Development Code Updates

Consider approval of Ordinance 2021-47, on the second of two readings, amending various sections of the City's development code, to among other things, address typographical and technical errors, and implement changes related to site permit requirements, detention, stormwater quality and stream protection, residential garage and pedestrian access requirements, building activation, the use of self-storage and outdoor storage, the Employment Center Zoning District, allowable uses in CD-2.5, ND-3.2, and the Land Use Matrix, providing a savings clause; providing for the repeal of any conflicting provisions; and providing an effective date.

Overview of Proposed Amendments

Section 4.3.5.11 Front Porch

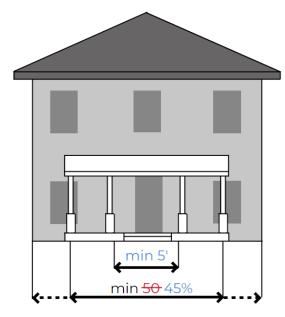
Purpose: Relates to the residential garage requirements and provides a minimum area for installing a front porch.

- 1. A front porch must be at least 6 feet deep (excluding the steps <u>and any porch posts</u>).
- 2. A front porch shall have a minimum area of 50 square feet.
- 3. Front porch posts which flank the front door, entry, or access point to the unit shall be separated a minimum of 5'.
- 4. A front porch must be contiguous with a width not less than 45 50% of the building facade.
- 5. A front porch must be roofed and may be screened but cannot be fully enclosed.
- 6. A front porch may extend up to 9 feet, including the steps, into a required front setback, provided that such extension is at least 2 feet from the vertical plane of any lot line.

Section 4.3.5.1 Residential Front Door Requirements

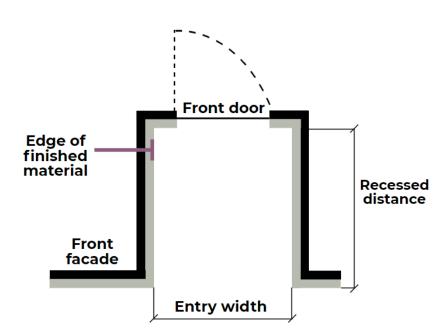
Scenario #1: If the front door is recessed 3 feet or less from the front façade, the entry shall be a minimum of 5 feet wide for the entire length of the entry.

Scenario #2: If the front door is recessed more than 3 feet, the entry shall be a minimum of 7 feet wide for the entire length of the entry.

- No architectural obstructions that reduce the passable width of the entry
- Measured from edge of finished material
- If front porch is proposed, see Section 4.3.5.11
